IN THE SPECIFICATION :

## REMARKS

Fig. 5

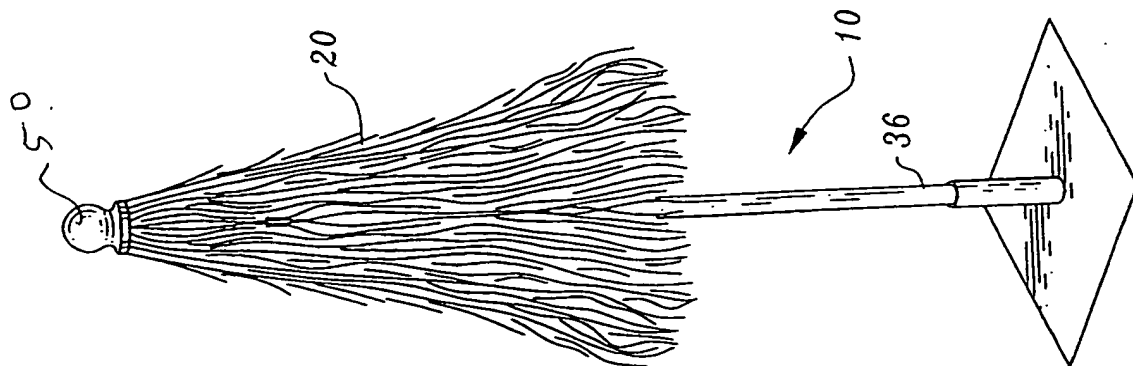
Such a disk configuration would be utilized if the construction of the umbrella were to omit a top finial [. See FIG. 8.] such as 50 shown in FIGURES 5 and 6.

In both the specification and the drawings the top finial is referred to by designator 50.

Fig. 7

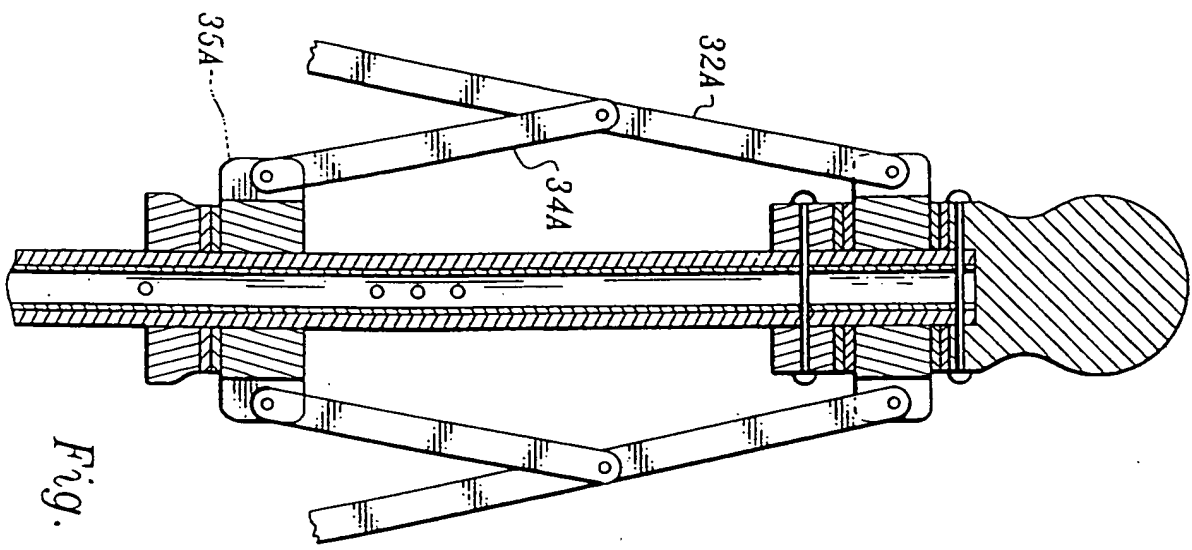
The change to FIGURE 7, as requested, has been authorized to add the legend, "PRIOR ART".

PRIOR ART
